### CASE / FORD NEW HOLLAND - Series 40 & 10

Item no. 3482 600 105

MF 330

Fig. 1: 330 mm Single diaphragm-spring clutch

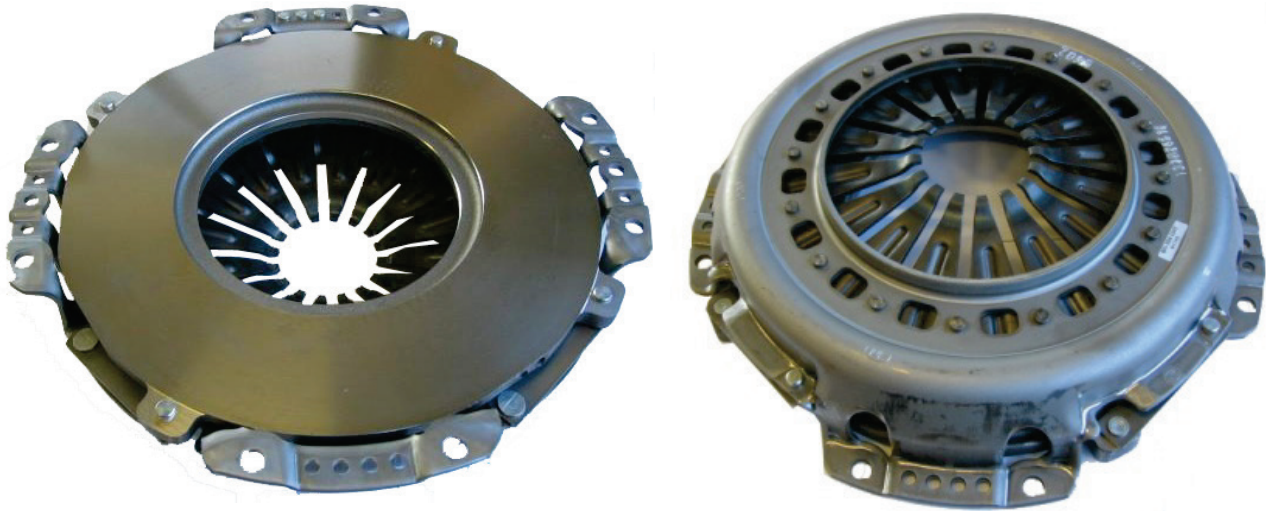
If you replace 4 lever coil spring clutch with a SACHS diaphragm spring-clutch, shims are not required.

You must use a SACHS Clutch disk with the SACHS diaphragm-spring clutch:

1878 600 520 > 320 mm	1878 600 519 > 330 mm	1864 600 304 > 330 mm
Clutch disk with torsional damping and 7 pairs of cerametallic linings	Organic Clutch disk with torsional damping	Organic, rigid Clutch disk
